AMENDMENT OF SOLICITATION/MODIFICATION OF CONTRACT

SUBJECT: LITTLE CALUMET RIVER, INDIANA, LOCAL FLOOD PROTECTION, STAGE 5 PHASE 2, MUNSTER, HAMMOND, AND HIGHLAND, INDIANA

1. By way of this Amendment 0001, the Bid Opening Date is extended from 6 September 2007 to 12 September 2007. The Bid Opening time remains the same at 2:00 p.m. Chicago Local Time.

SHEET REFERENCE NUMBER:
S-20
SHEET 96 OF 138

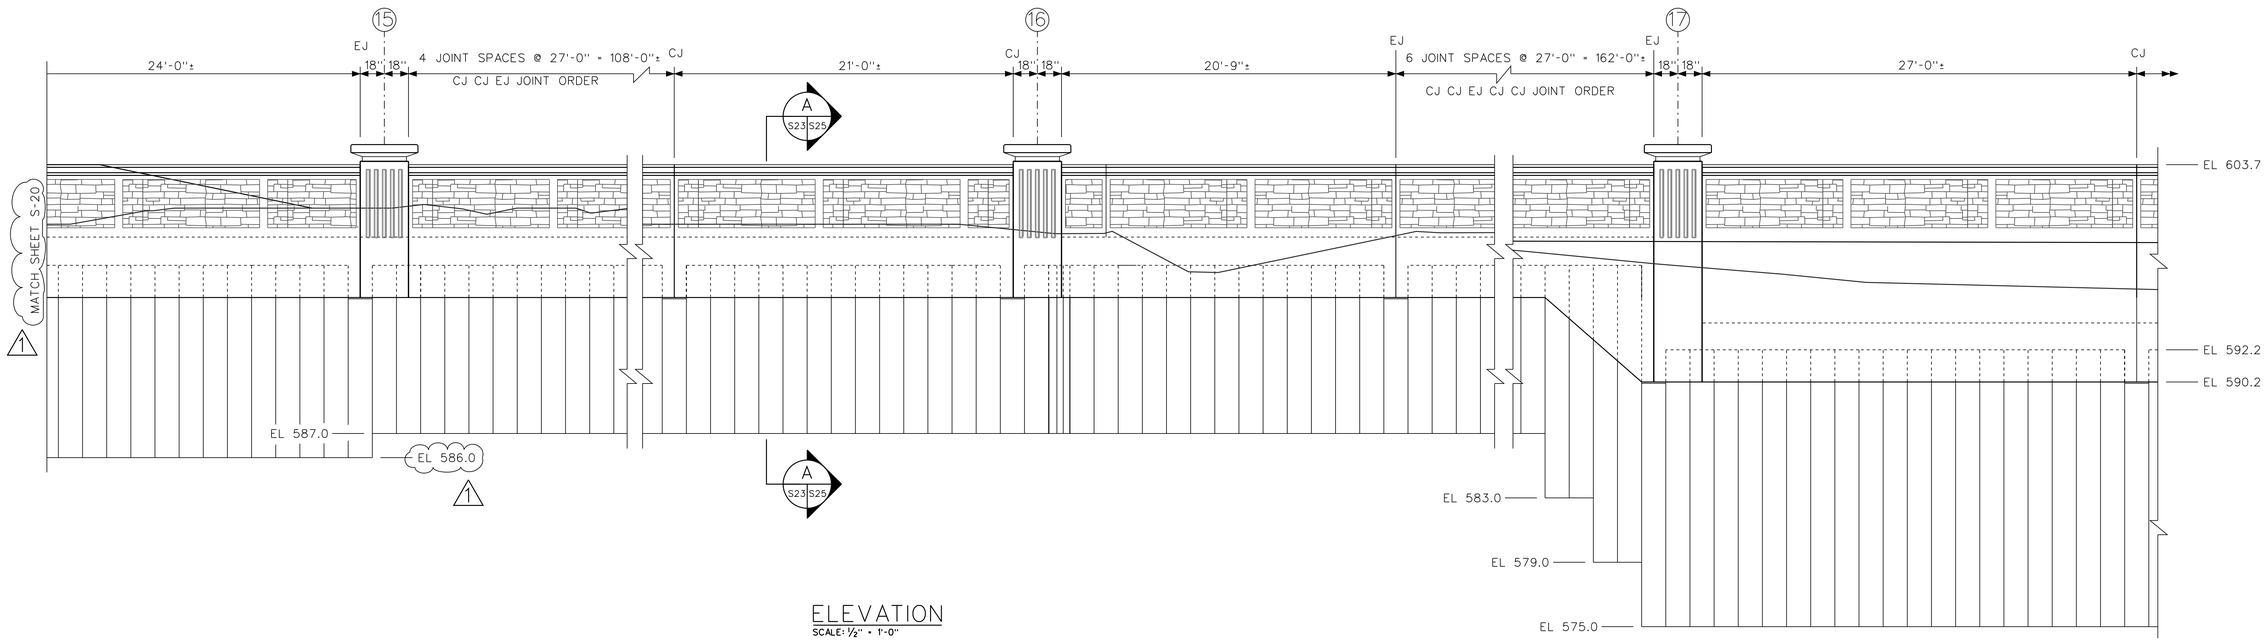
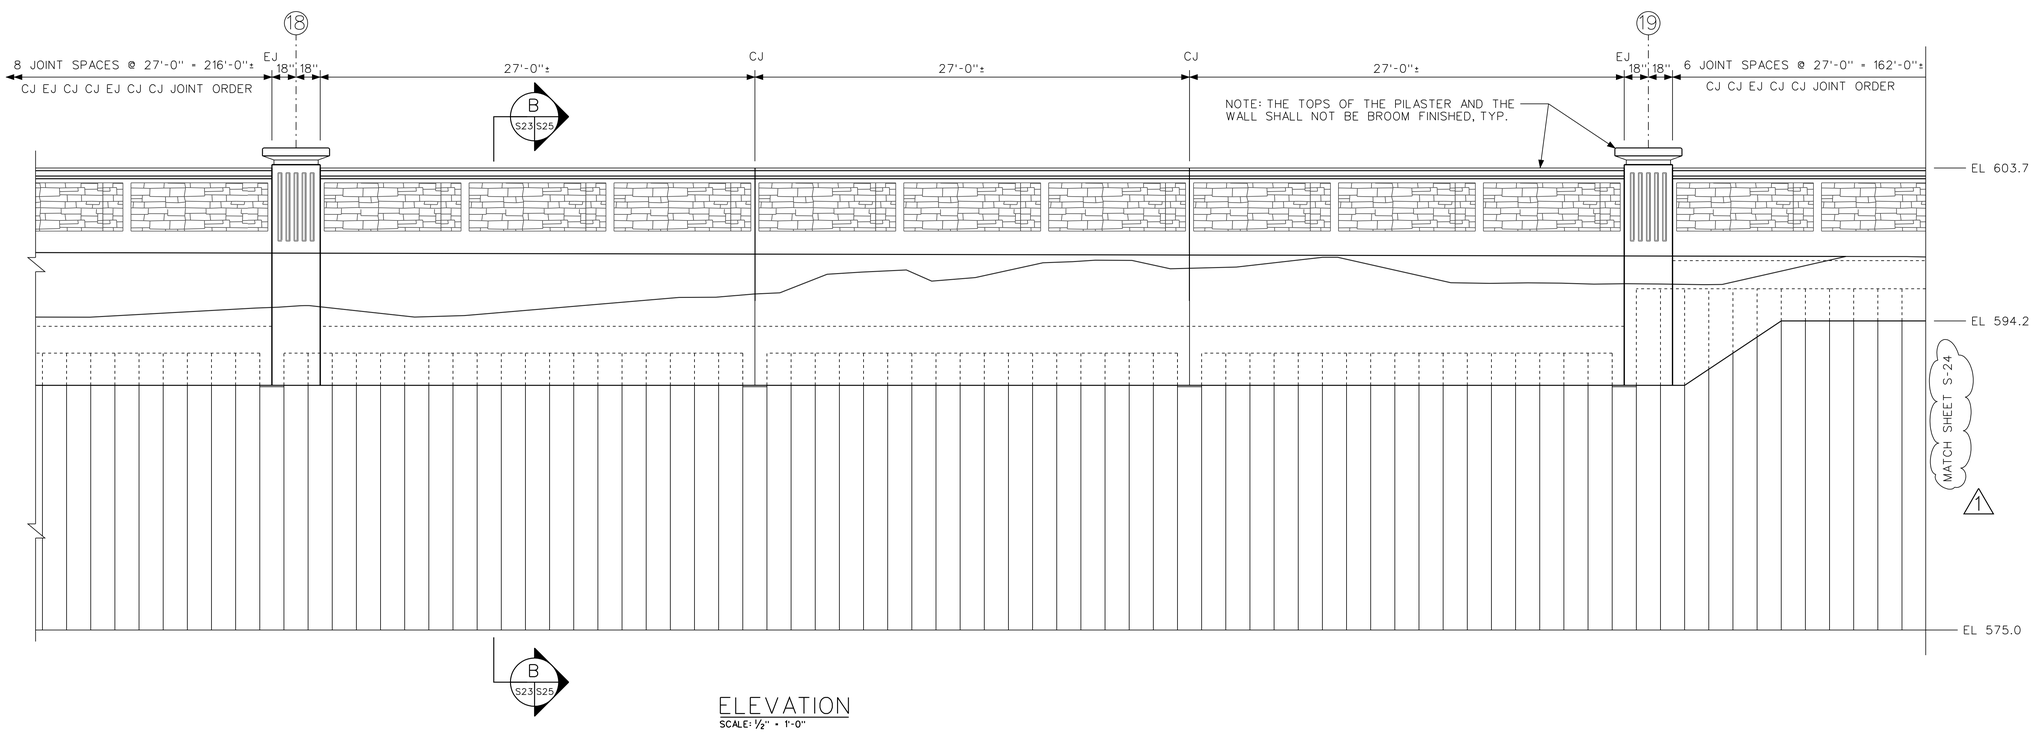
Question 24. Sheet S-20 at location H2 there is an indication that the wall continues but there is no match line shown – what is the east end of this I wall?

Question 46. Sheet S-19 shows a match line at location F2, it says S-15 but it appears to be S-20 – vice versa for sheet 20, also on sheet S-20 at location H2 there should be a match line which looks like it should be S-23 – please comment.

Response 24. This wall continues as the North Drive I-Wall and it matches with Drawing Sheet S-23 – revisions have been made by way of this Amendment 0001.

<u>Response 46</u>. Drawing Sheets S-19, S-20 & S-23 have been corrected by way of this Amendment 0001; the Revised Sheets are attached hereto.

SHEET REFERENCE NUMBER:
S-32
SHEET 108 OF 138

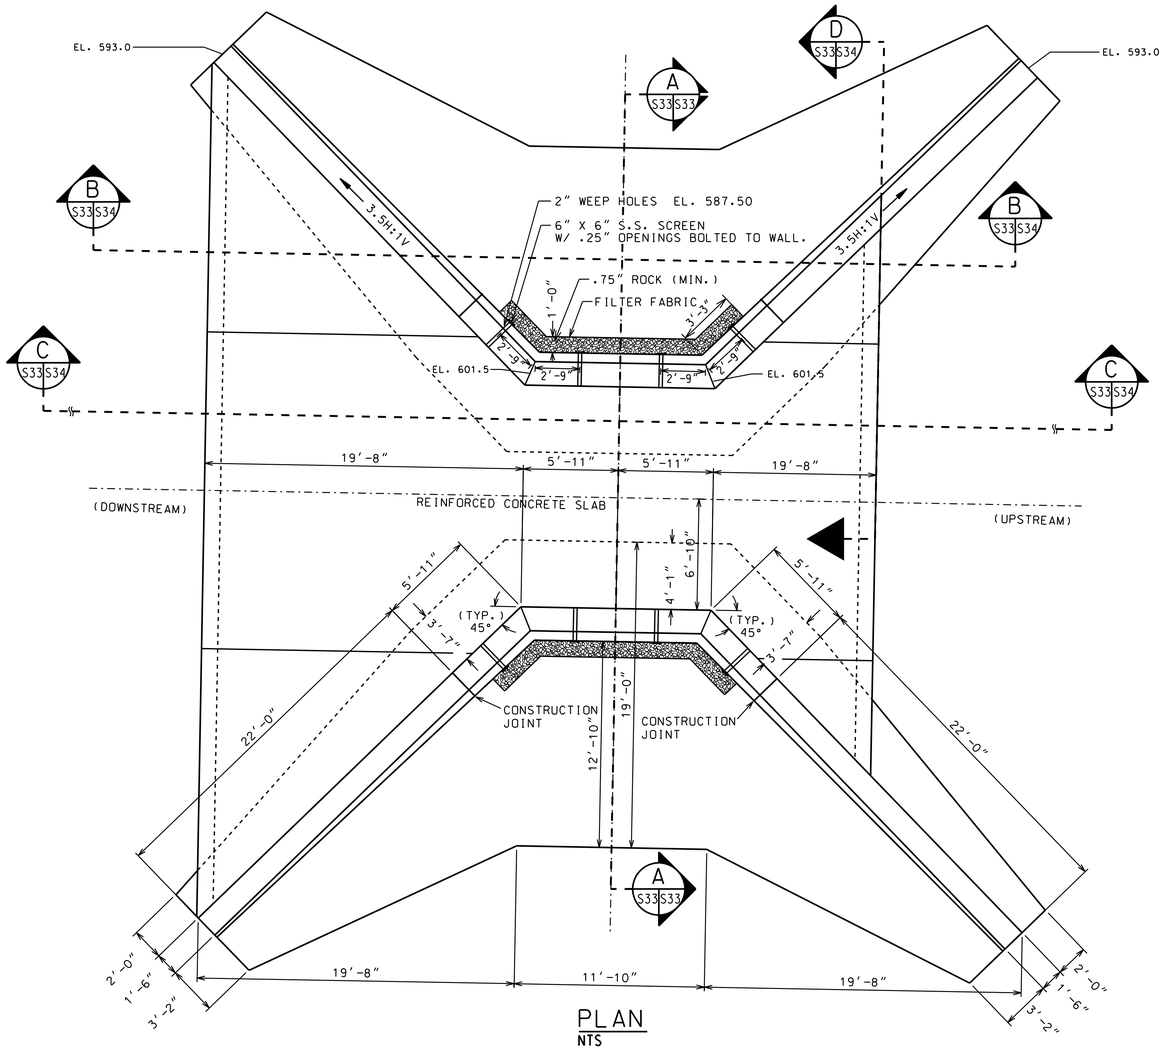
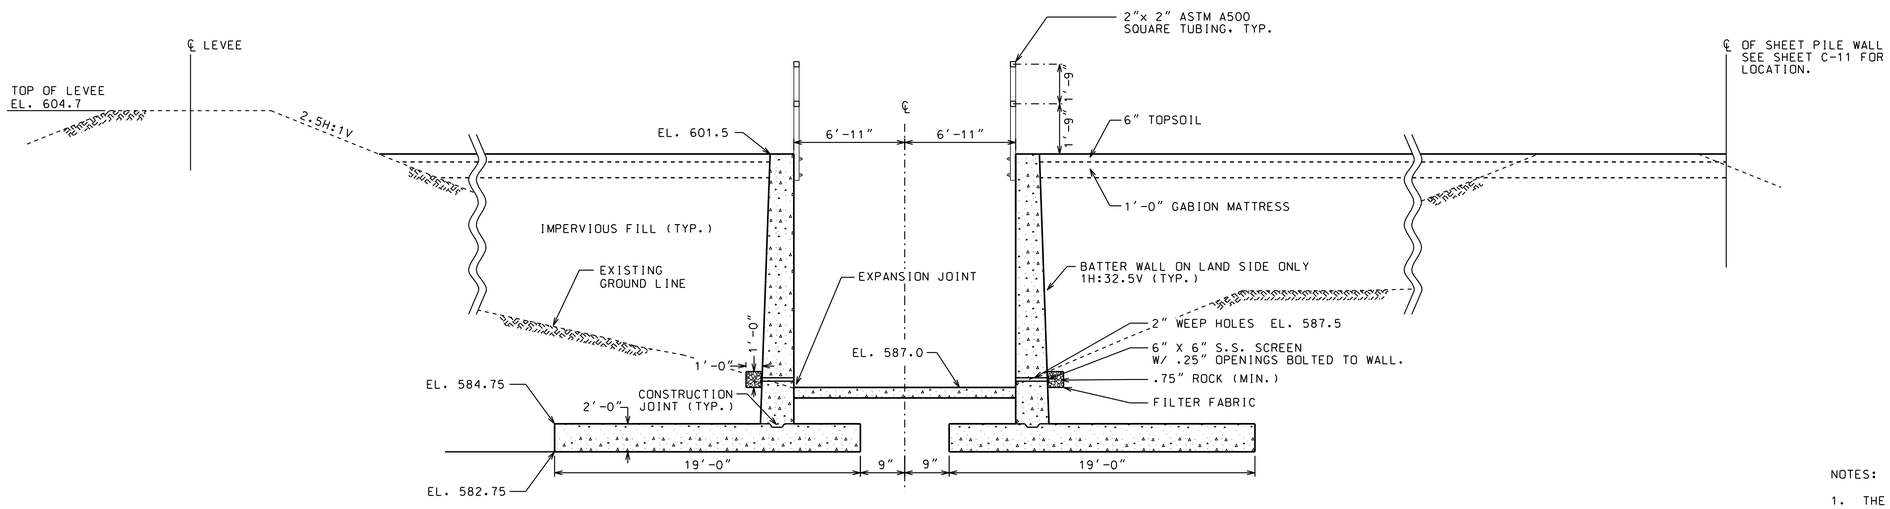
Question 26. Sheet S-32 – the dimension for the bottom of the parapet is missing on section B – please comment.
